# International Aero Engines SERVICE BULLETIN

Subject: Transmittal of Revision 1 to Service Bulletin No. V2500-ENG-73-0084

ENGINE - FUEL AND CONTROL - FUEL SYSTEM TUBES -  
INTRODUCTION OF RE-ALIGNED LP FUEL TUBE  
ASSEMBLY PRODUCED FROM STAINLESS STEEL MATERIAL

# V2500-ENG-73-0084

General View  
Fig 1

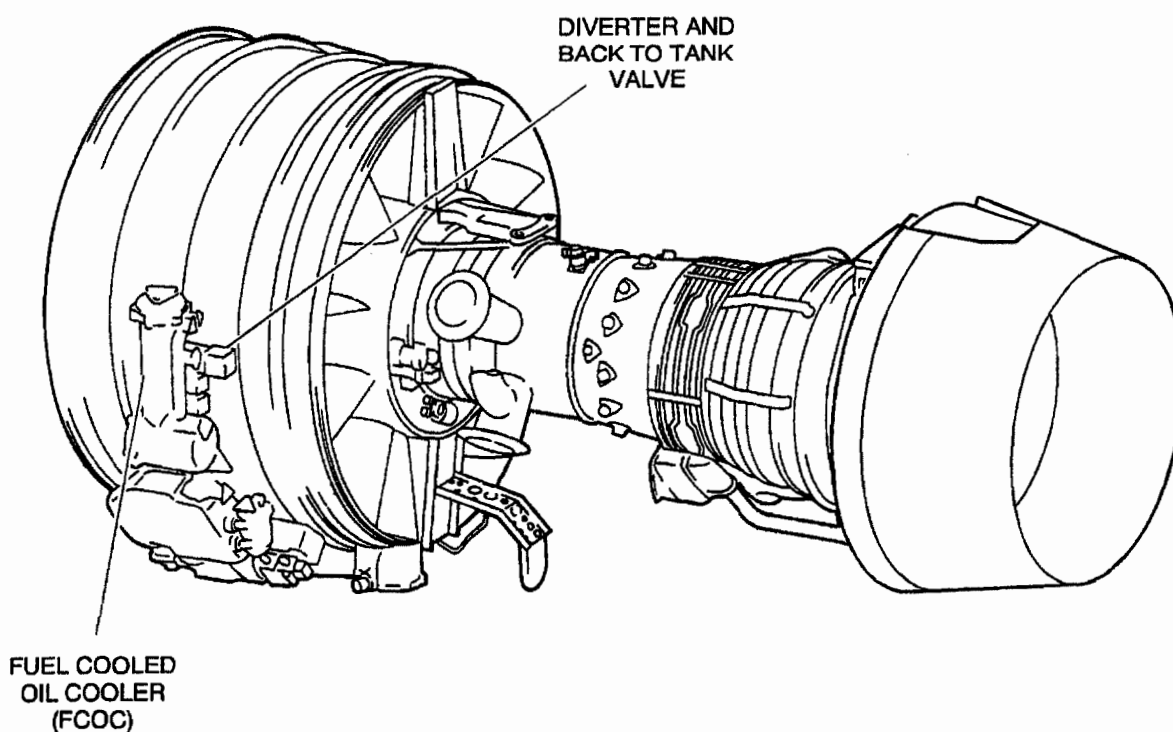
R This Service Bulletin introduces a revised LP fuel tube assembly between  
R the FCOC and the diverter valve with the changes that follow:

- (a) The tube material has been changed from titanium to stainless steel.
- R (b) The ferrule has been revised to contain a centralising spigot to  
control alignment to the FCOC mounted seal housing.
- R (c) The length of the tube assembly has been increased so that more of  
R the ferrule goes into the FCOC mounted seal assembly.
- R (d) The tube assembly will be produced with more tightly controlled  
R tolerances at the tube end locations. This will make sure that the  
tube is manufactured correctly and as a result, reduce the  
possibility of misalignment.

- R (1) Before the new fuel tube is installed, make sure that the inner diameter  
R of the 5W8201 mating seal housing has been inspected for fretting and  
wear in accordance with the appropriate inspection check. (Refer to the  
Component Maintenance Manual, Chapter/Section 73-11-49,  
Inspection/Check-02.)
- R (2) Install the new 6A6484 fuel tube. For the correct procedures, refer to  
R the A1/A5 Engine Manual (EM), Chapter/Section 72-00-32, Installation-20.
